Proposed New Layout and Magnet

Old slides

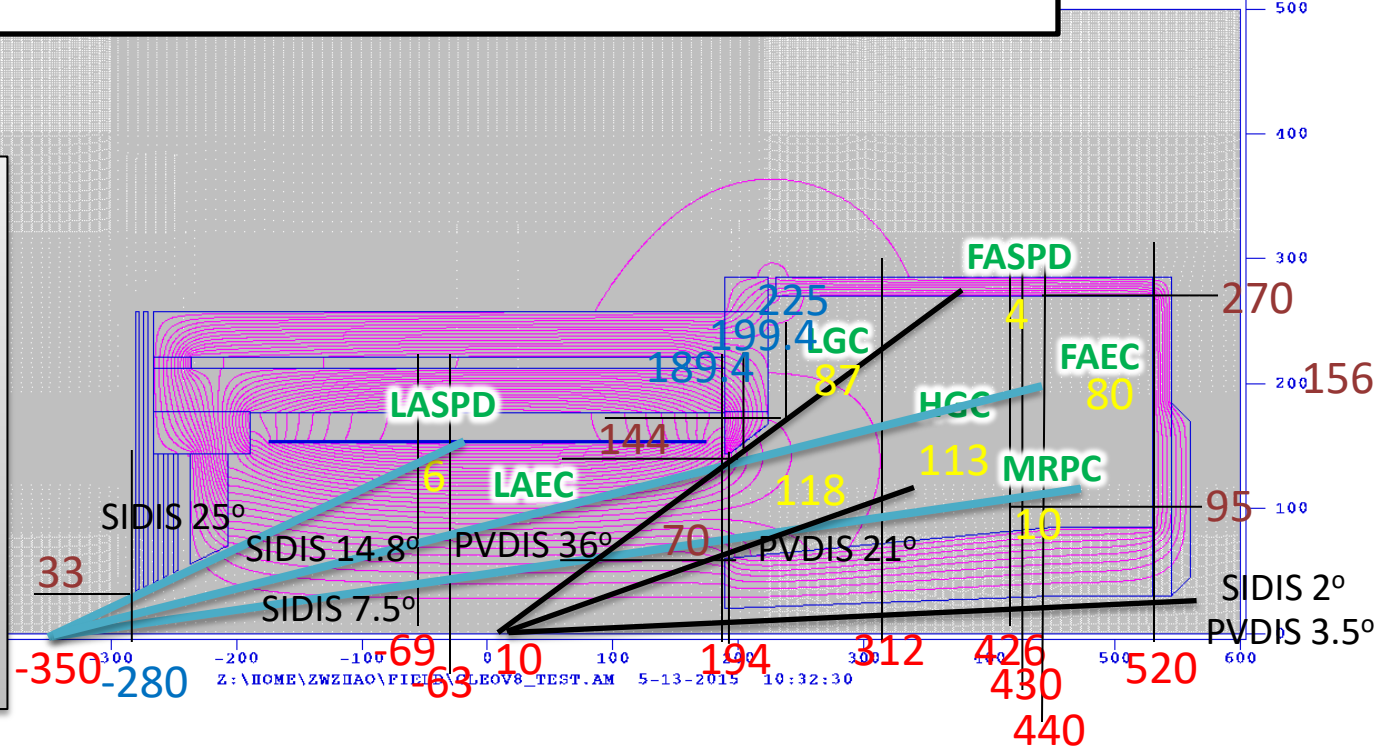
enlarge endcap space in Z by 35cm=(520-485)

increase endcap nose size in R from 60 to 70cm and from 90 to 95cm

Zhiwen's old slide

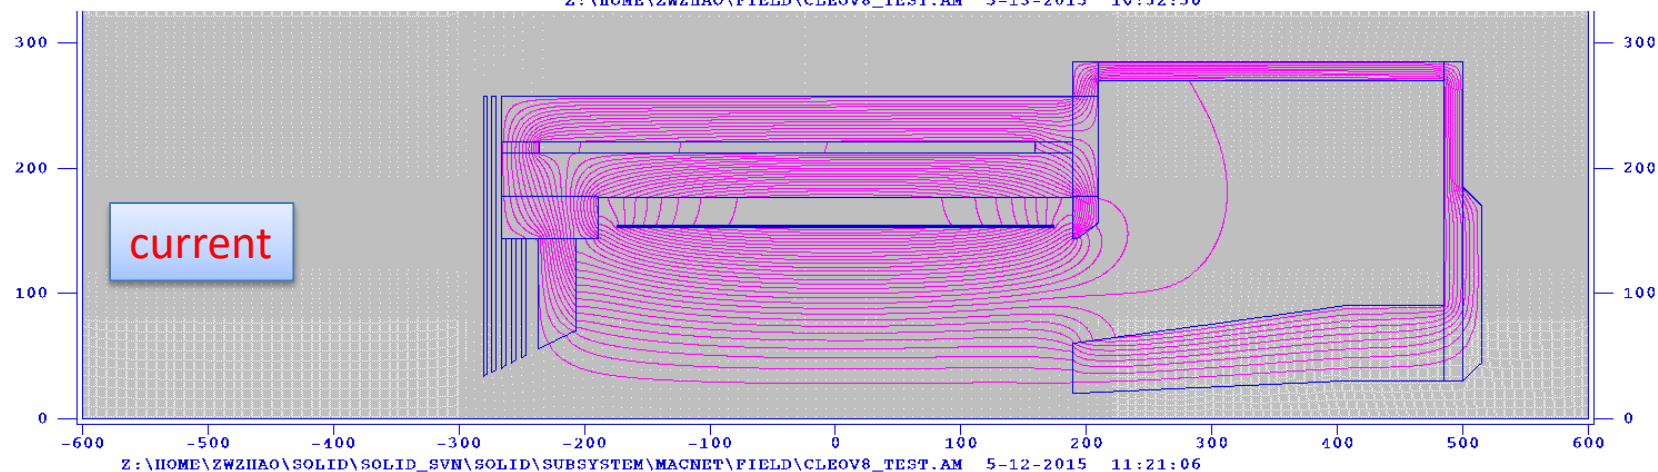
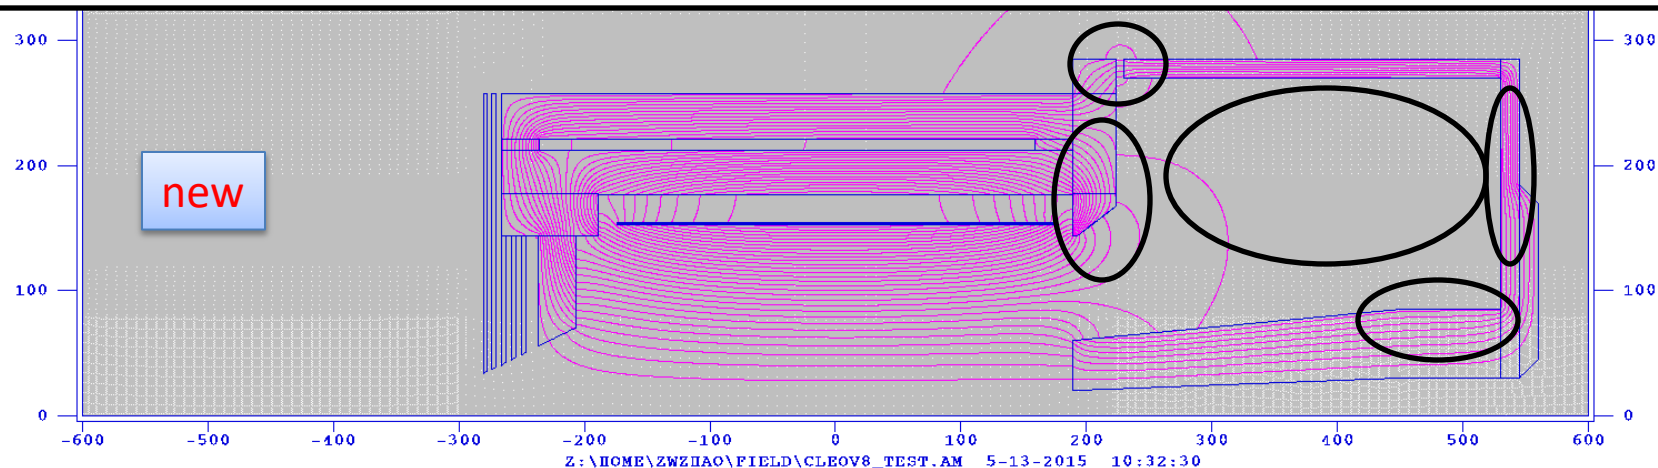
Just ideas here, but changes are clearly needed

- Downstream collar enlarge by 15cm in z (needed for engineering)
- Endcap enlarge 30cm (SIDIS setup needs room)
- Endcap nose back reduce 5cm in r (EC hexagon module needs room)
- 6cm gap between downstream collar and endcap (let cable out, more cable out at back needed)
- possible impact, PVDIS EC large angle performance

Jay's new model

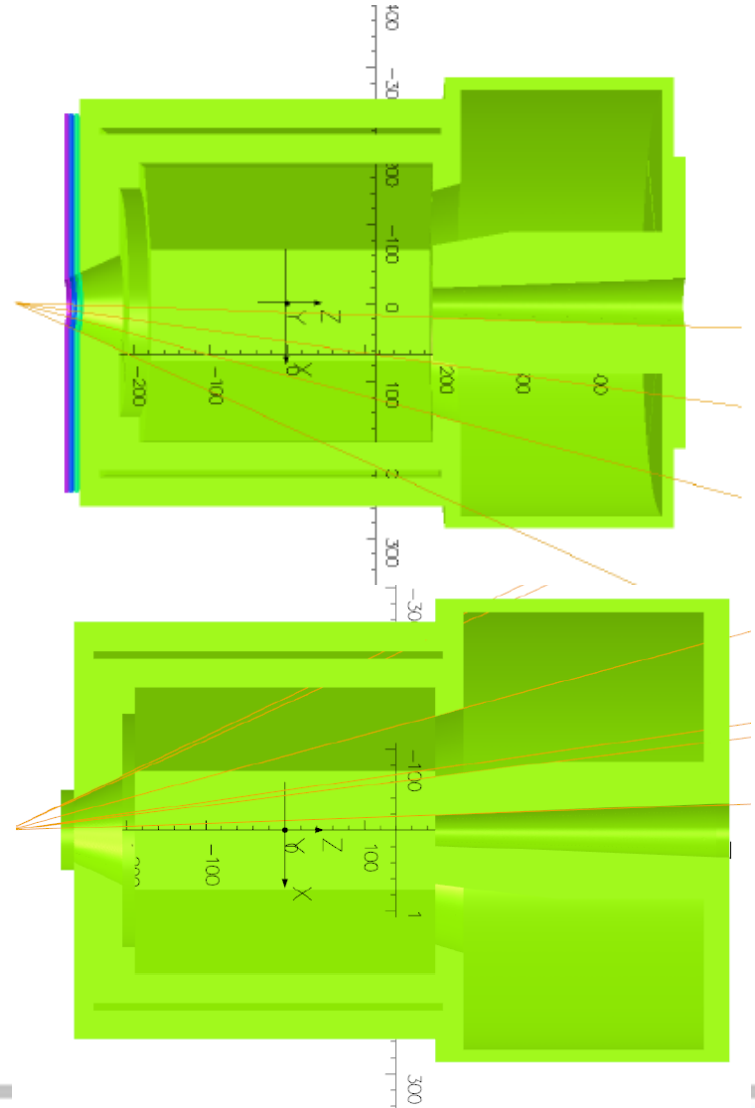
- 1. how long should endcap interior be, including contingency for detector changes? The one shown is 304.8 cm. Zhiwen's model has 261 cm.
- 2. what should OD of endcap central cylinder be? Range 85-90 cm. One could slot a 90 cm cylinder and recess Thomson rails: intermediate steel case.
- 3. what size radial holes are needed at what endcap Z locations for cables? 24 2" diameter with external compensatory steel?
- 4. how much will ~ 2 G excursion in Bz over 60 cm He3 target affect it?
